SUBJECT: Forwards addl info re revised pressure/temp curves in response to SER Confirmatory Item 11. Allowances for differences between RCS temp & reactor vessel flange region temp discussed.

SHEARON HARRIS NUCLEAR POWER PLANT
UNIT NO. 1 - DOCKET NO. 50-400
REVISED PRESSURE/TEMPERATURE CURVE

Shearon Harris Nuclear Power Plant
SER Confirmatory Item No. 11
Pressure/Temperature Curve

FIGURE 1
CRITICAL CROSS SECTIONS

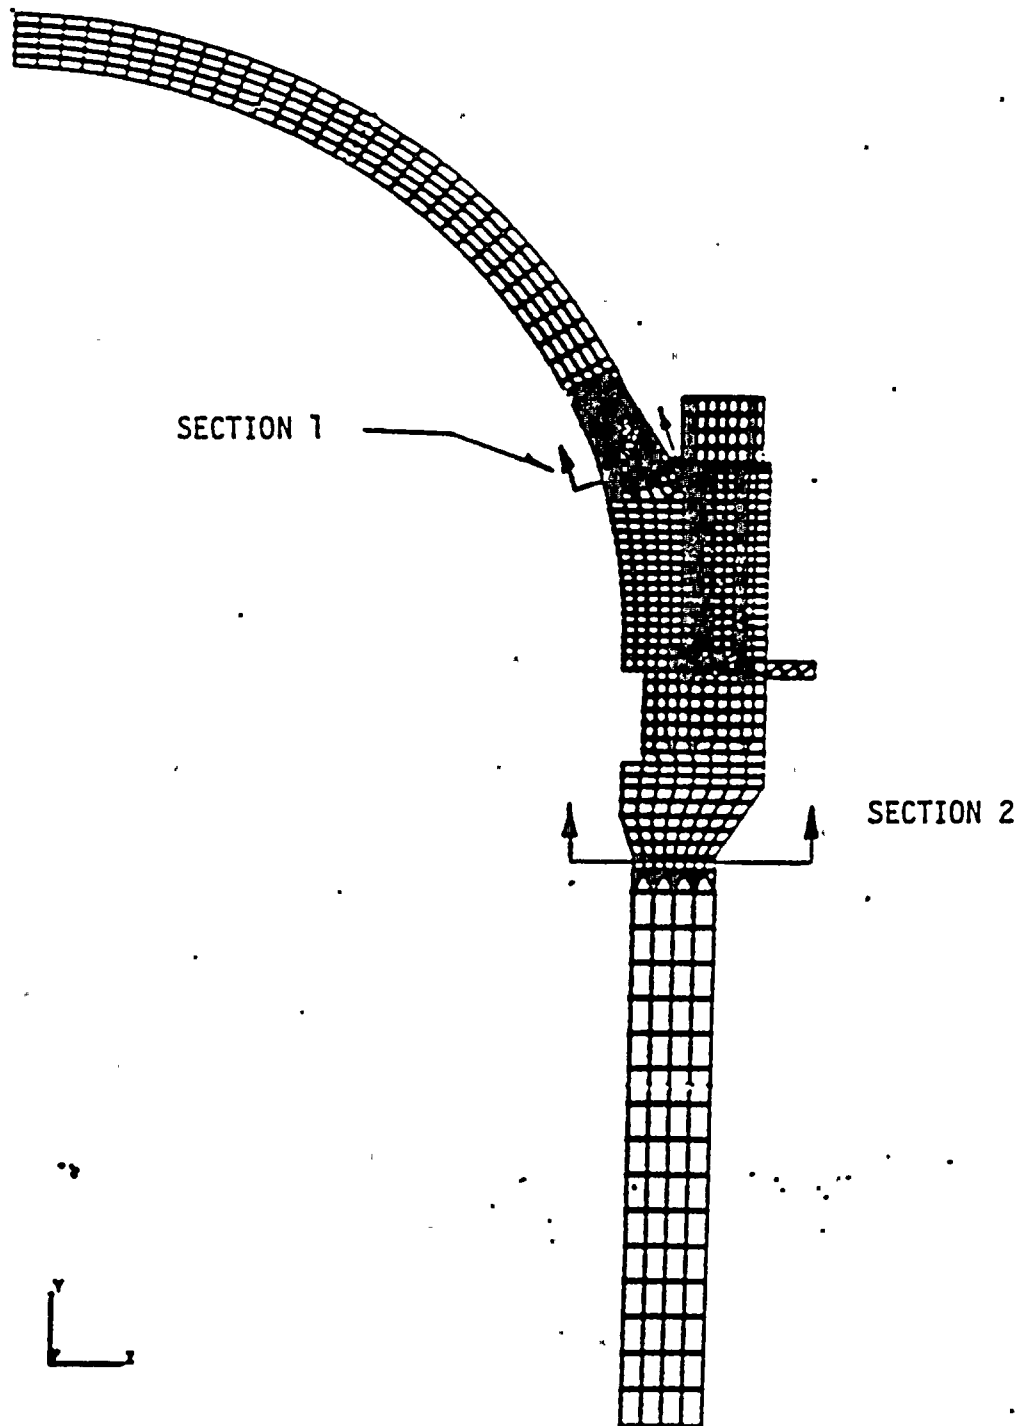
Provide additional information concerning the allowance for temperature differences between the RCS coolant temperature and the Reactor Vessel Flange region temperature.

The critical regions of interest for the temperature lag during normal heatup in the closure head and vessel flange regions are cross sections 1 and 2 shown in Figure 1. A finite element model was used for the analysis to obtain temperature gradients caused by heatup transients. All exterior surfaces of the model were assumed to be perfectly insulated and, therefore, adiabatic. Figure 2 shows the thermal boundary conditions.

During the 60 degree F per hour heatup transient, the temperature at the outside surface at cross section 1, of Figure 1, lags the coolant temperature by 58.1 degrees F. In order for the metal temperature at this location to be 128 degrees F, the coolant temperature has to be 58.1 degrees above 128 degrees F or 186.1 degrees F. The Figure 1, cross section 2, temperature lag is 51.2 degrees F during the 60 degrees F per hour heatup transient, and the coolant temperature has to be 163.2 degrees F for the metal temperature to be 112 degrees F. As a result, the new 10 CFR 50 rule including temperature lag limits the SHNPP pressure to 621 psig until a coolant temperature of 186 degrees F is reached. Comparison of this pressure-temperature point with Figure 3 shows that the new 10 CFR 50 rule does not impact the SHNPP 60 degrees F per hour heatup curve.

During the 100 degree F per hour heatup transient, the temperature at the outside surface of Figure 1, cross section 1, lags the coolant temperature by 74.1 degrees F. In order for the metal temperature at this location to be 128 degrees F, the coolant temperature has to be 74.1 degrees F above 128 degrees F or 202.1 degrees F. The Figure 1, cross section 2, temperature lag is 92.8 degrees F during the 100 degree F per hour heatup transient, and the coolant temperature has to be 204.8 degrees F for the metal temperature to be 112 degrees F. As a result, the new 10 CFR 50 rule including temperature lag limits SHNPP pressure to 621 psig until a coolant temperature of 204.8 degrees F is reached. Comparison of this pressure-temperature point with Figure 3 shows that the new 10 CFR 50 rule does not impact the SHNPP 100 degree per hour heatup curve.
